Pineville
PLANNING & ZONING

Re: **Conditional Zoning Proposal for ILIM School (***Public Hearing/ Action Item***)**

REQUEST:
Dria Etienne on behalf of ILIM Montessori School seeks your consideration for a site-specific conditional zoning development to allow the school of (approximately 290 students) at 505 Towne Centre Blvd. Schools are permitted in the zoning district. The conditional zoning request is to allow a parking lot in the front yard.

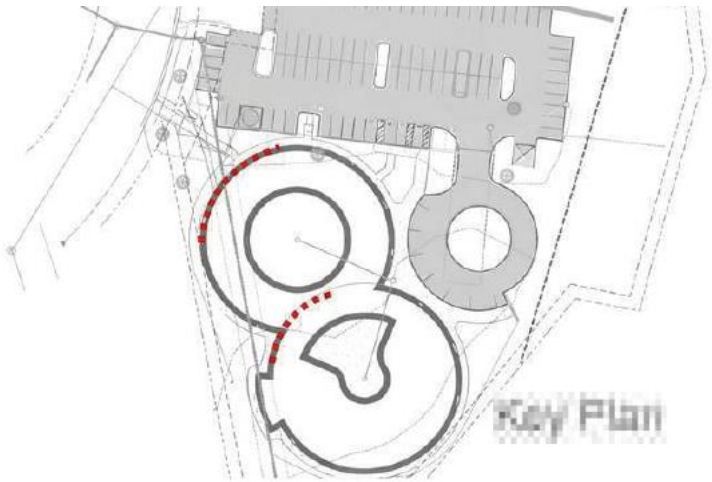
Façade: Elevations have been improved with brick and brick detailing but need to confirm all portions of the facades visible to the public from Towne Centre Blvd will be brick. Since the building is round recommended is 50% of the facades facing the road be the brick façade detail shown on the attachments.

STAFF COMMENT:
Applicant has been in review with the county and has had initial engineering and stormwater review. Recommend brick façade expanded further than just the dotted red area shown below to fully cover view from the street per the overlay requirements. Parking lot is existing in the front yard but is not recommended because it does not meet the Downtown Overlay and keeps the building closer to the creek and flood issues. Towne Centre has been known to flood and become impassable to cars.

Staff does not find the proposal consistent with the Downtown Overlay regarding brick coverage area and parking lot design.
